RE: Compliance Evaluation Inspection

Garfield County Ticaboo Class II Landfill

# GARFIELD COUNTY TICABOO CLASS II LANDFILL INSPECTION MARCH 19, 2014

Looking south at the steep working face of the landfill

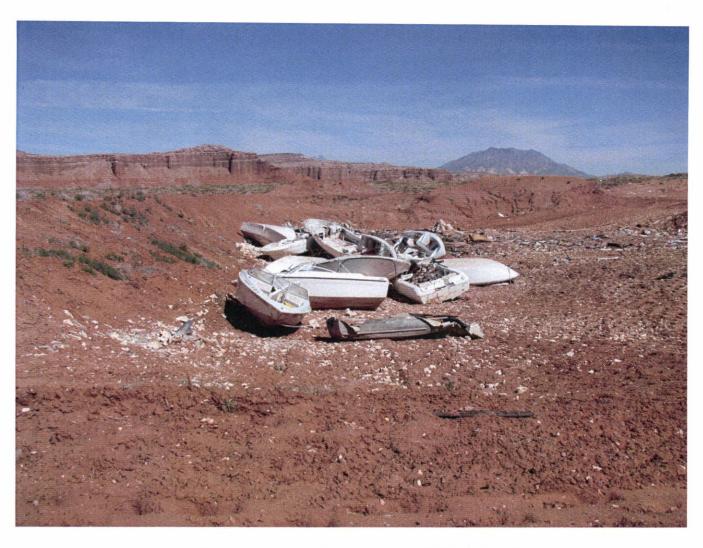
Looking at the working face and the lack of daily soil cover
